Subject : Current Configurations of Pressure Suit and Parachute

The results of the meeting on January 16 thru 18 with regard to changes in the pressure suit and parachute are as follows:

FULL PRESSURE SUIT 1962
OXCART

[] WITHOUT SUIT - NECK SPREADER COLLAR

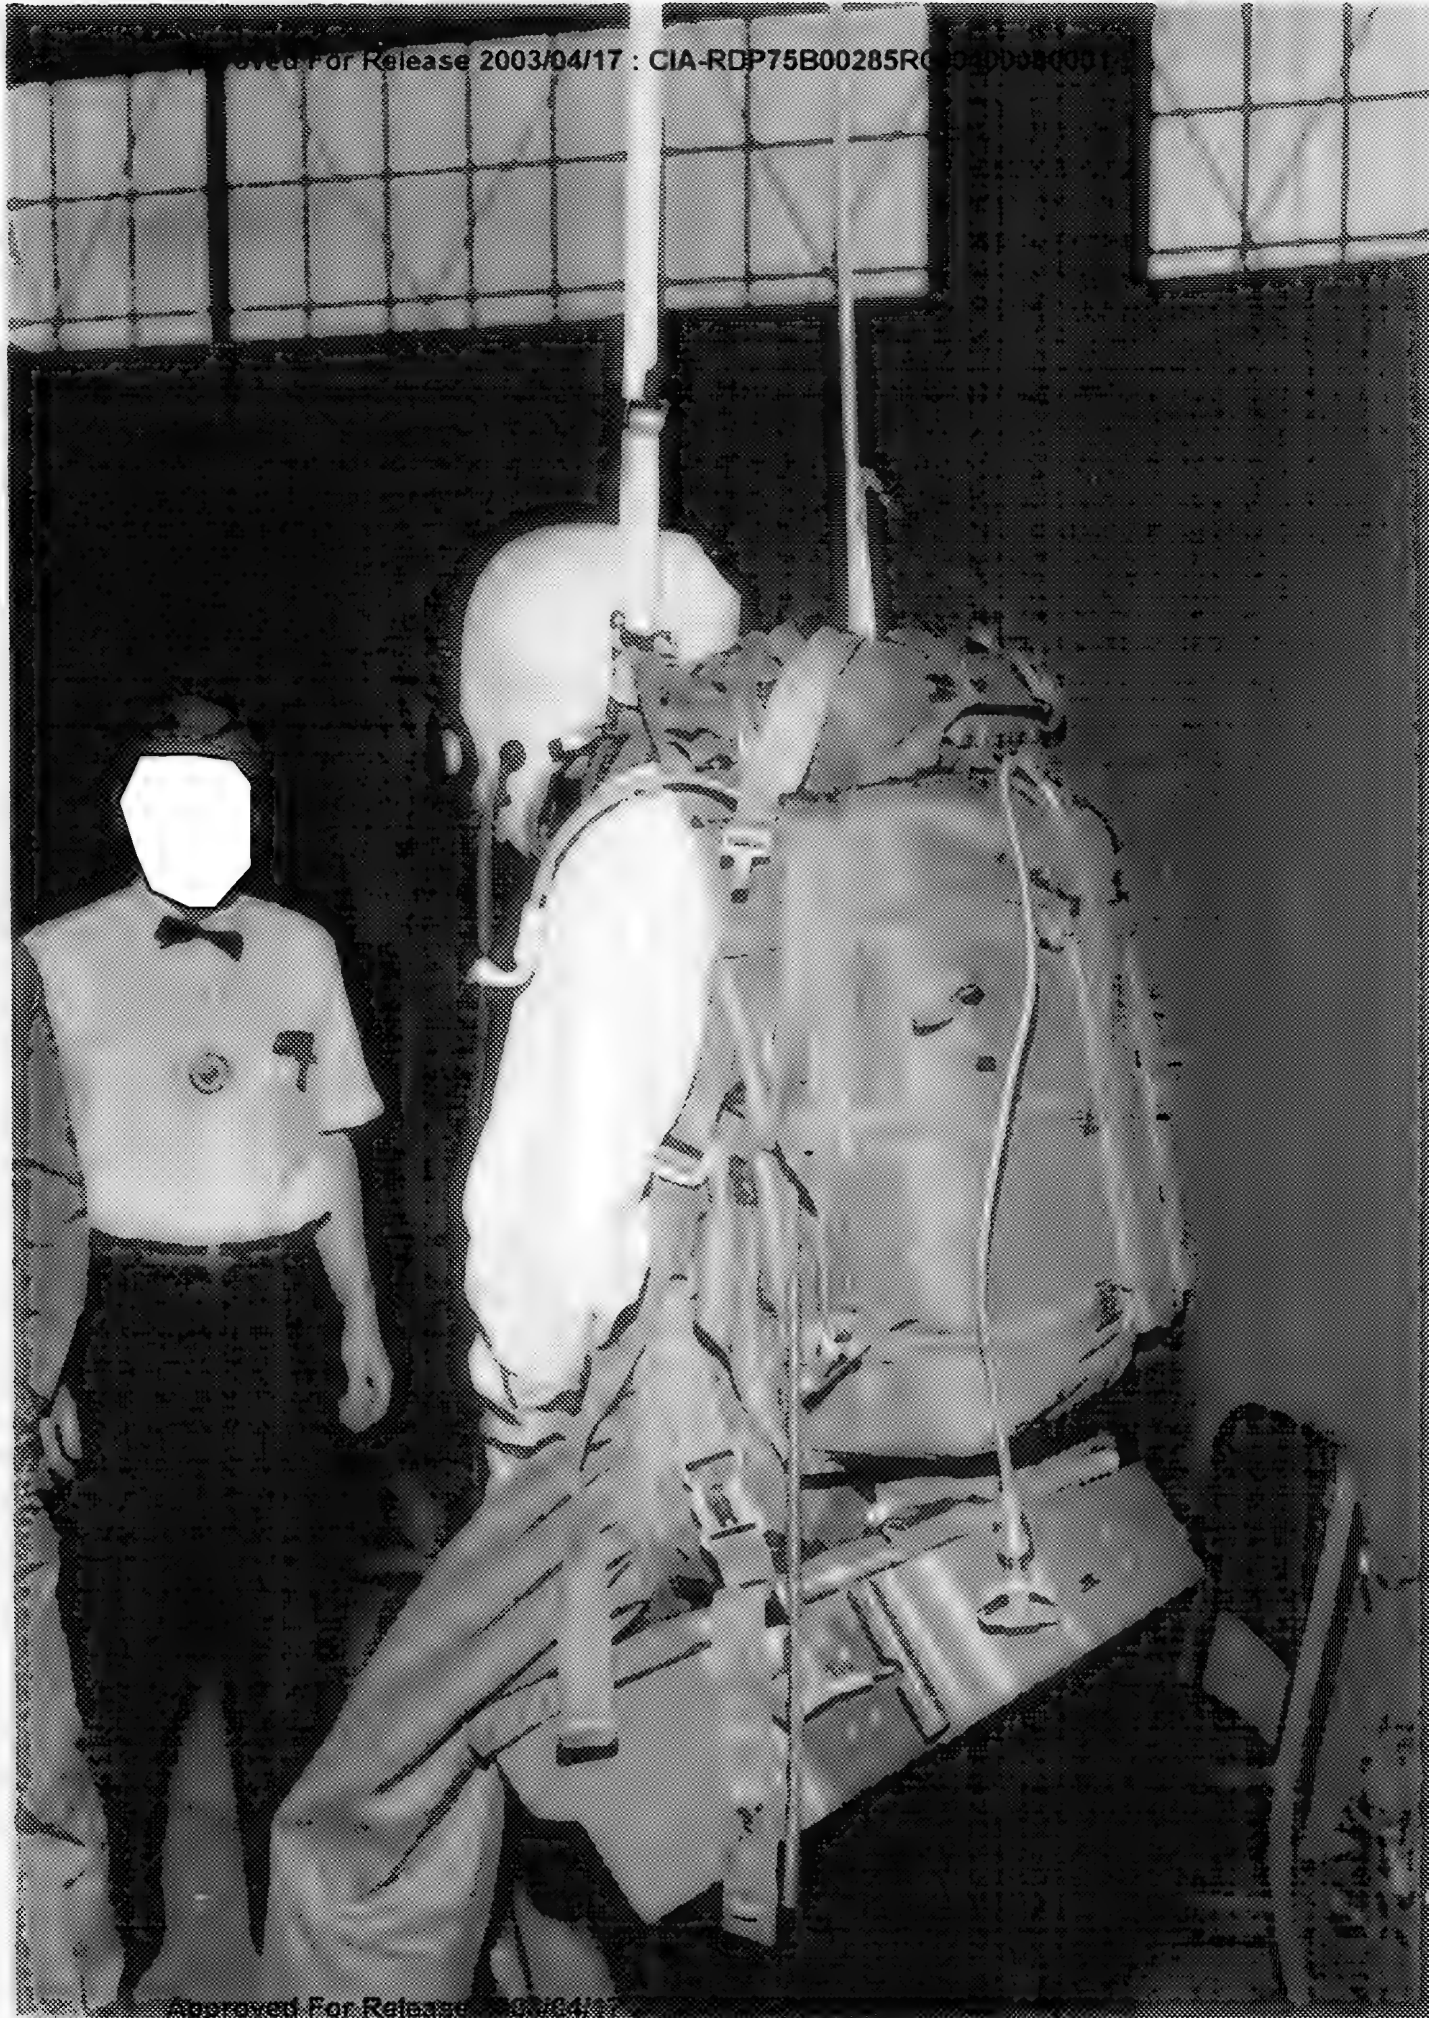
a) KIT WEIGHTED 40[#]

b) SUSPENSION 1ST STAGE

COMMENTS BY []

a) COMPLAINS ABOUT ^{CHEST} ~~NECK~~ PRESSURE -
CONSIDERS HIGH

b) CONSIDERS GROIN COMFORT OK

c) SUSPENSION LINE THRU C.G. APPEARS OK.
FOR COMFORT

SAME RIG AS

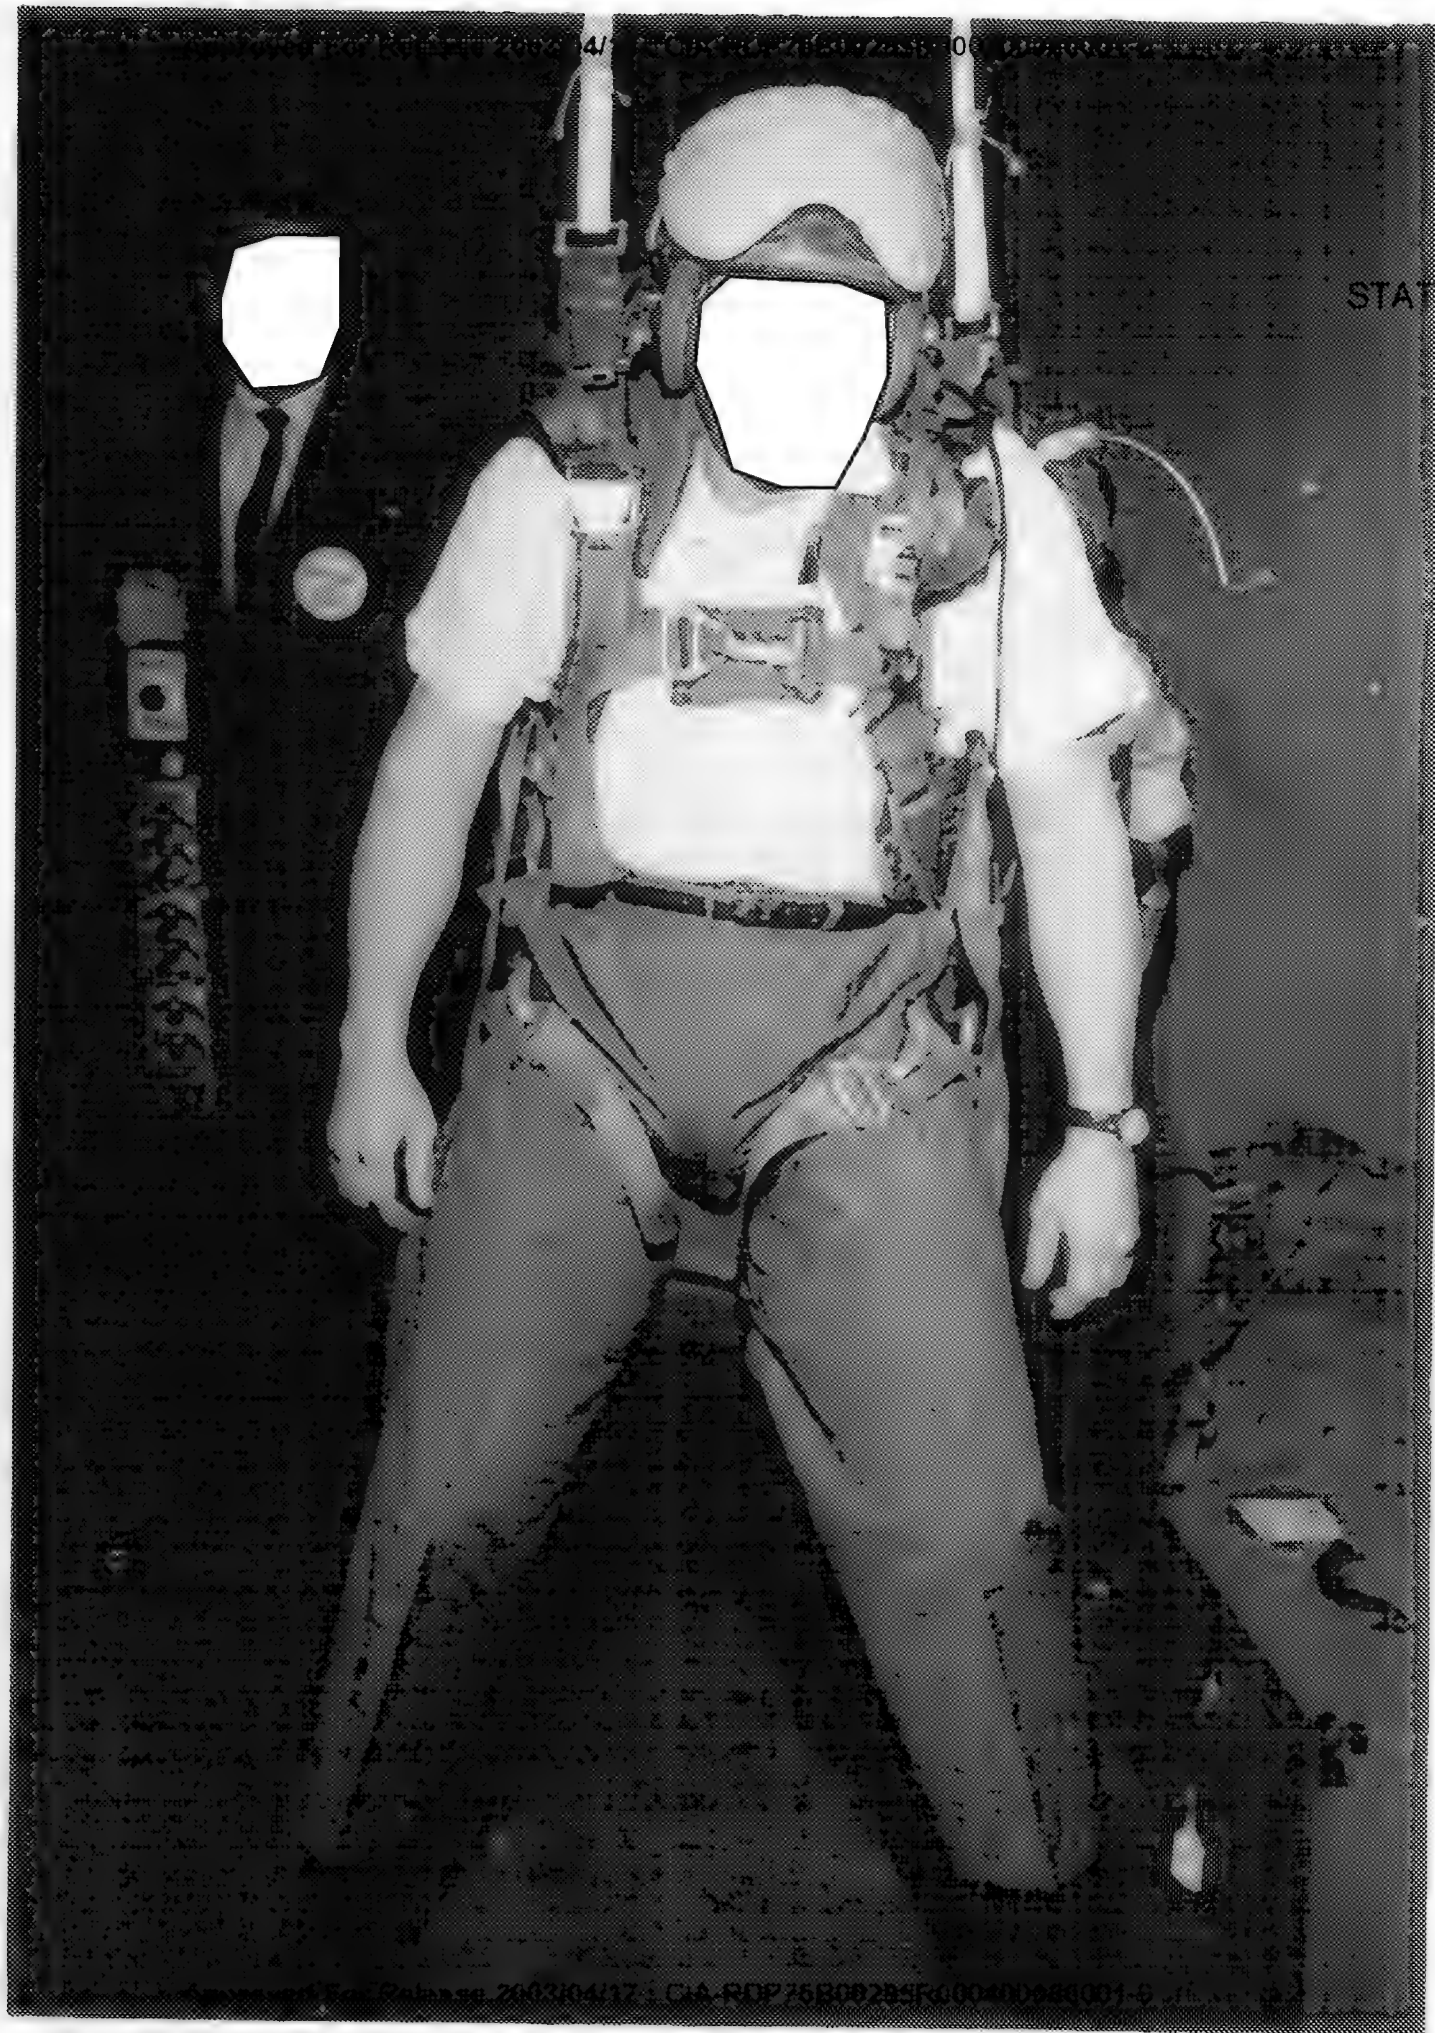
- a) CLEARS HELMET OK
- b) COMPLAINS ABOUT COMFORT
AT LEGS AND NECK
- c) PRESSURE FROM NECK COLLAR
